ADDRESS: 1018 WINTER ST

Proposal: Demolish and reconstruct upper floors with roof deck

Review Requested: Final Approval

Applicant: Sam Xu, Constrecture LLC

A0

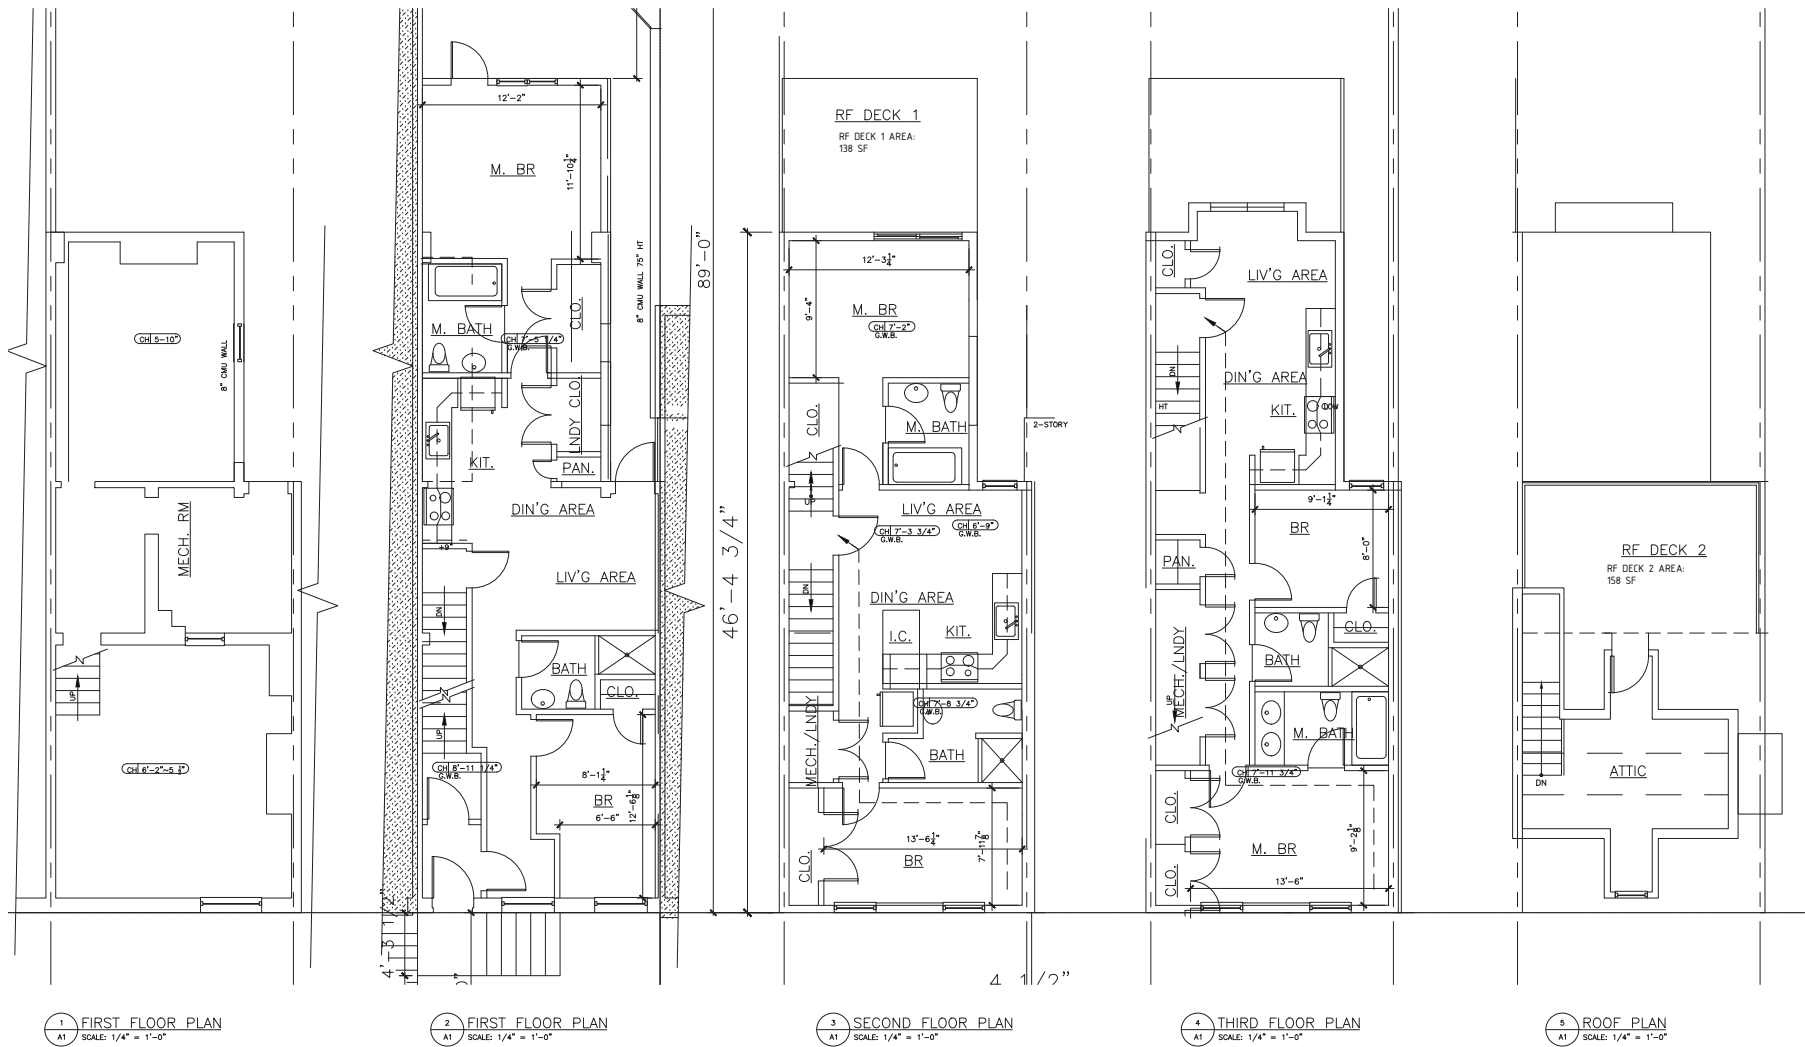
- *Standard 2: The historic character of a property will be retained and preserved. The removal of distinctive materials or alterations of features, spaces, and spacial relationships that characterize a property will be avoided.*
 - The application proposes a significant amount of demolition to the front of the building; therefore, the application does not meet Standard 2.

- If the front wall and roof must be replaced, as recommended in the structural report, they should be replaced in-kind and not include an additional floor level.

- The proposed alterations to the front façade do not meet Standard 9 in terms of scale and proportion.
 - The proposed increase in size and massing at the rear of the property overwhelms the original form and environment of the historic building and does not meet Standard 9.

- The proposed demolition and new construction permanently alter the historic building's form and integrity; therefore, the application does not meet Standard 10.

STAFF RECOMMENDATION: Denial, pursuant to Standards 2, 9, and 10.

4 BLDG LONGITUDINAL SECTION
A2 SCALE: 1/8"=1'-0"

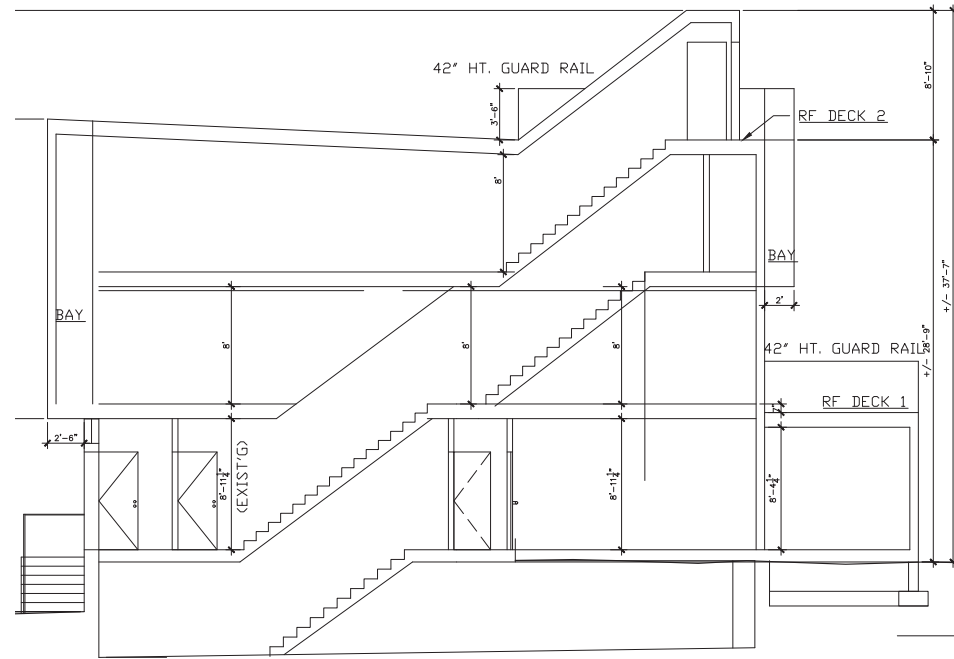
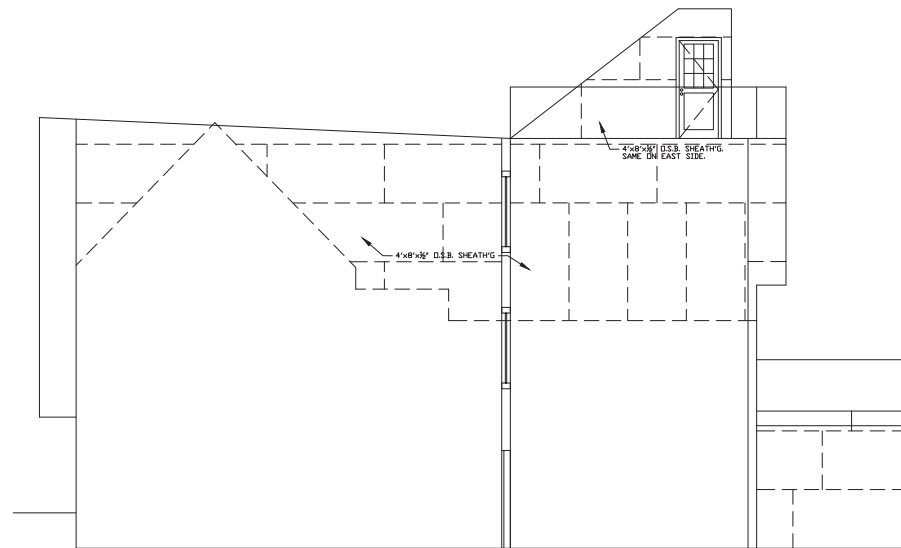
- Mr. Weiner pointed out to Mr. Leong that that is not what his application is proposing.
 - Ms. Gutterman agreed and pointed out that the application drawings show a completely new front facade and new interior. She said that this is not an acceptable intervention to an individually designated property. Ms. Gutterman recommended that the applicant and owner think about restoring the front elevation of the building and maintaining the gable roof and dormer. She said that rear of the building could be modified with a compatible renovation or new construction in terms of massing and scale.

- Mr. Detwiler agreed that any new construction would need to occur at the back of the building, not at the front.

- A structural engineering report should be submitted with an assessment of the building's structural integrity and identification of unsafe areas.
- To satisfy the Standards, the proposal should be revised to maintain the building's main block and limit changes to the rear that are compatible with the materials, features, scale and proportion of the main block.
